UNITED STATES PATENT AND TRADEMARK OFFICE

APPLICATION NO.	FILING DATE	FIRST NAMED INVENTOR	ATTORNEY DOCKET NO.	CONFIRMATION NO.	
10/7.72,657	02/05/2004	Brian C. Adamski		5580	
7590 11/15/2004			EXAM	EXAMINER	
GREER, BURNS & CRAIN			HESS, DOUGLAS A		
300 South Wacker Drive, Suite 2500 Chicago, IL 60606-4002			ART UNIT	PAPER NUMBER	
g -,		•	3651		
			DATE MAILED: 11/15/200	4

DETAILED ACTION

FIG. 14

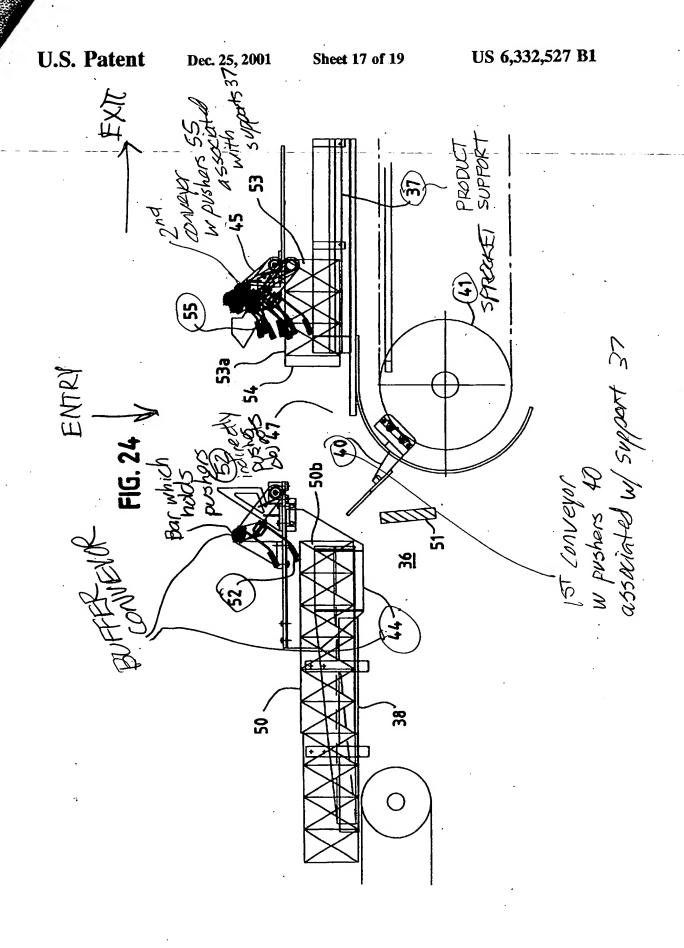
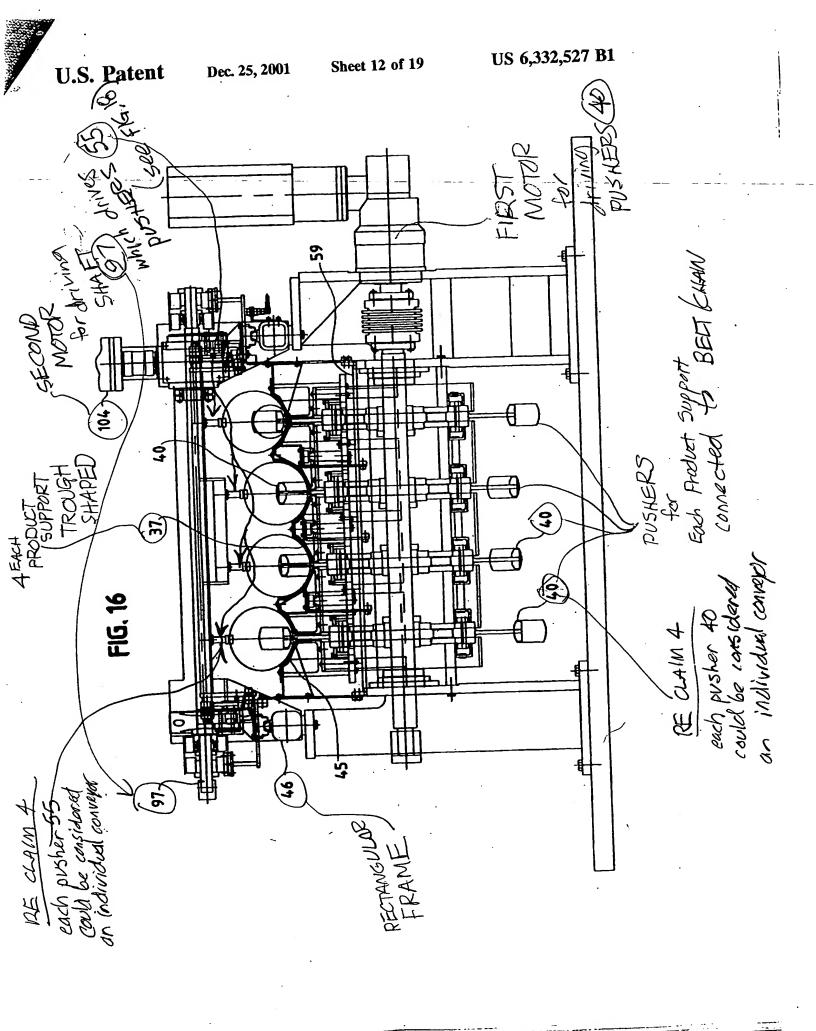
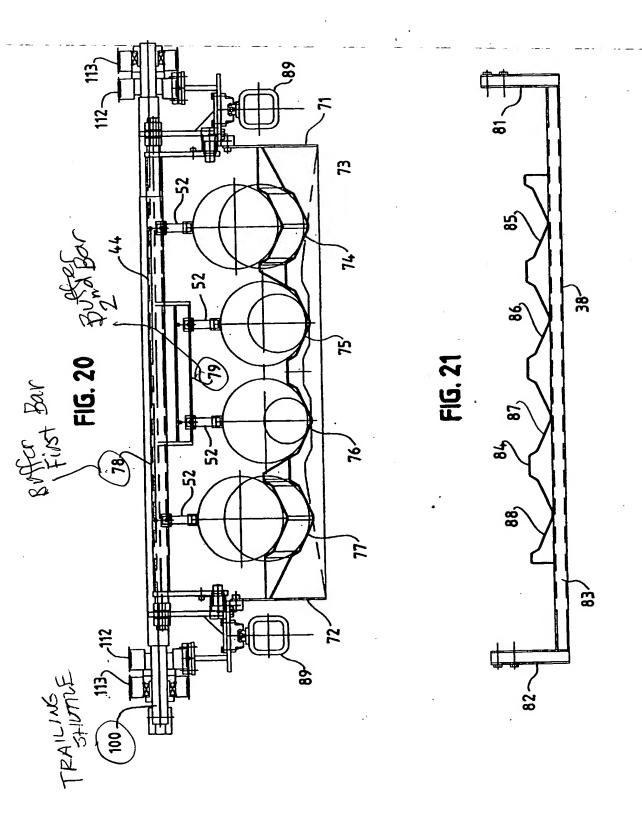
- (b) the invention was patented or described in a printed publication in this or a foreign country or in public use or on sale in this country, more than one year prior to the date of application for patent in the United States.
- 4. Claims 1-13 are rejected under 35 U.S.C. 102(b) as being anticipated by Wierschke (US Pat No. 6,33,527).

See the attached marked up drawing figures 14-16, 20, and 24 of Wierschke depicting the claimed features.
